Braidwood Station, Units 1 and 2
Facility Operating License Nos. NPF-72 and NPF-77
NRC Docket Nos. STN 50-456 and STN 50-457

Byron Station, Units 1 and 2
Facility Operating License Nos. NPF-37 and NPF-66
NRC Docket Nos. STN 50-454 and STN 50-455

Subject: Response to Request for Additional Information Regarding License Amendment Request to Utilize WCAP-16143-P, Revision 1, as an Analytical Method to Determine the Reactor Coolant System Pressure and Temperature Limits

Development of Responses to NRC RAIs Pertaining to WCAP-16143-P Revision 1 for Braidwood Units 1 and 2 and Byron Units 1 and 2

Figure 1: Distribution of Point Loads at Boltup - All Studs Intact

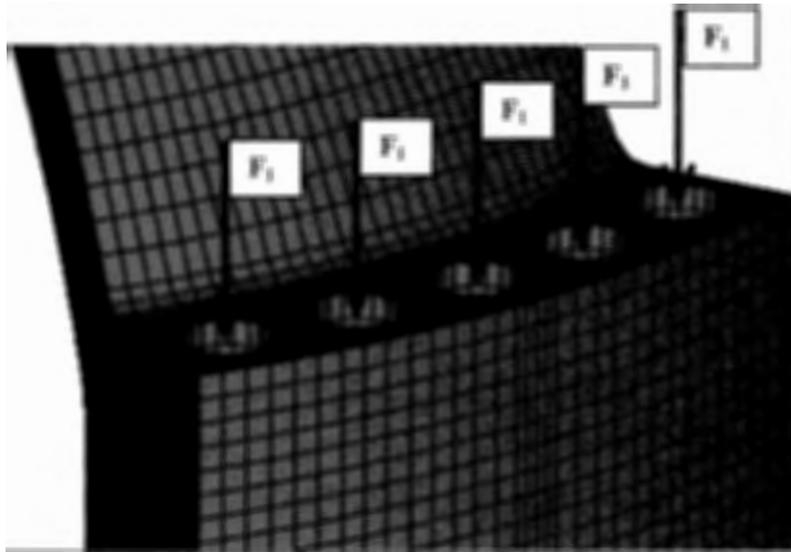
NRC RAI 2: The NRC staff notes that during heatup and cooldown for the missing stud case, the load due to pressure that had been taken by the missing stud was redistributed to the nearby studs, most likely to the two studs immediately adjacent to the missing stud. Intuitively, the stresses in the flange location in question at the stud cut plane immediately adjacent to the missing stud cut plane (at the 6.66° cut plane shown in Figure E-3 “Upper Head/Flange Region Stress Cut Planes”) would be higher than those in the same cut plane for the case where there is no missing stud. In order to allow verification of the fidelity of the finite element analysis results, identify the stresses in the flange in the center-of-stud cut plane (6.66° cut plane) after the 0° cut plane.

For the condition during bolt-up with all studs intact, the flange load can be viewed as the distribution of point loads from the tension of each stud. Figure 1 below shows a representation of this condition (all studs intact) with uniform tension on each stud (F_1) and a uniform distribution around the flange. For the 5-stud sector shown, the total stud load would be $5 \cdot F_1$ and the bending stress in the flange transition region would also be uniform as shown in the related stress plot in Figure 2.
